DEVELOPMENT APPLICATION ASSESSMENT REPORT

Application Number:	DA2023/0951
Responsible Officer:	Adam Croft
Land to be developed (Address):	Lot 5 DP 4689, 46 Prince Alfred Parade NEWPORT NSW 2106 Lot 6 DP 110670, 46 Prince Alfred Parade NEWPORT NSW 2106 Lot 262 DP 752046, 46 Prince Alfred Parade NEWPORT NSW 2106 Lot 329 DP 824292, 46 Prince Alfred Parade NEWPORT NSW 2106
Proposed Development:	Alterations and additions to the Royal Motor Club Broken Bay
Zoning:	RE2 Private Recreation W2 Recreational Waterways
Development Permissible:	Yes - Zone RE2 Private Recreation Yes - Zone W2 Recreational Waterways
Existing Use Rights:	No
Consent Authority:	Northern Beaches Council
Delegation Level:	NBLPP
Land and Environment Court Action:	No
Owner:	Royal Motor Yacht Club Broken Bay NSW NSW Government - Department of Industry - Lands
Applicant:	Royal Motor Yacht Club Broken Bay NSW
Application Lodged:	21/08/2023
Integrated Development:	No
Designated Development:	No

The application seeks consent for alterations and additions to the Royal Motor Yacht Club Broken Bay (RMYC), primarily involving a new two-storey addition to the west of the existing buildings and swimming pool area.

Figure 1 - Illustration of the approximate proposed building height breaches in relation to the lift shaft and balustrades (shaded red)

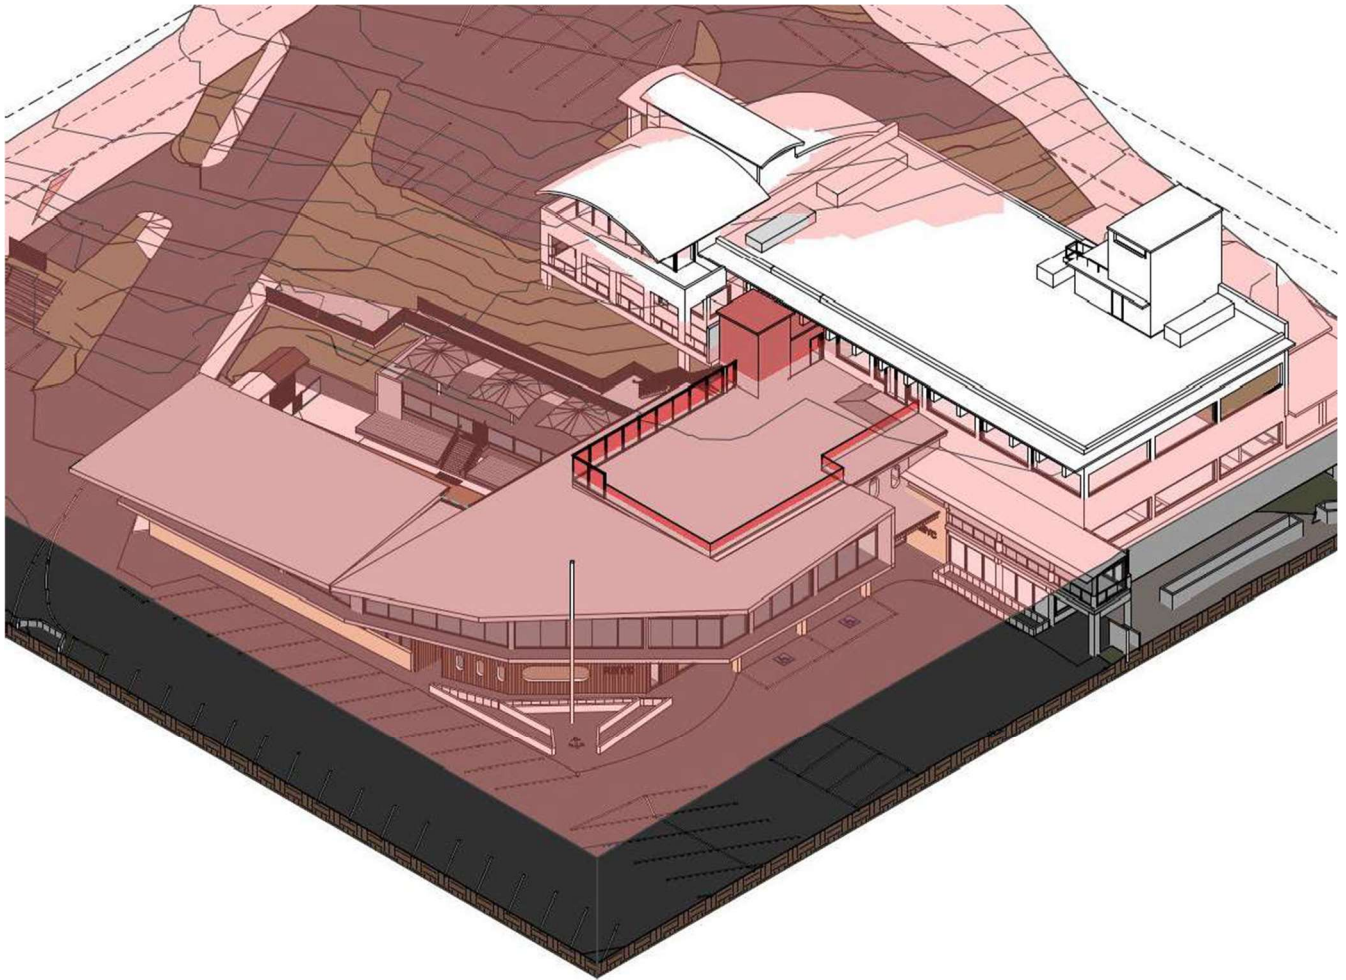
Development standard:	Height of Buildings
Requirement:	8.5m
Proposed:	13.1m
Percentage variation to requirement:	54.1%

The above height plane diagram is not certified, however the portions of buildings projecting above the height plane (lift shaft and glass balustrades shaded red) are generally in alignment with measurements taken from the submitted plans and are presented in a more practical format than a two dimensional sectional drawing. On that basis, the diagrams are included for illustrative purposes. Figures 2 and 3 below indicate Council's calculation of the proposed maximum building height breaches.

Given the particularly minor proportion of the built form that exceeds the height control and the absence of material visual or amenity impacts, grounds 1 to 4 above as advanced in the applicant's Clause 4.6 variation request are accepted as sufficient environmental planning grounds in the case.
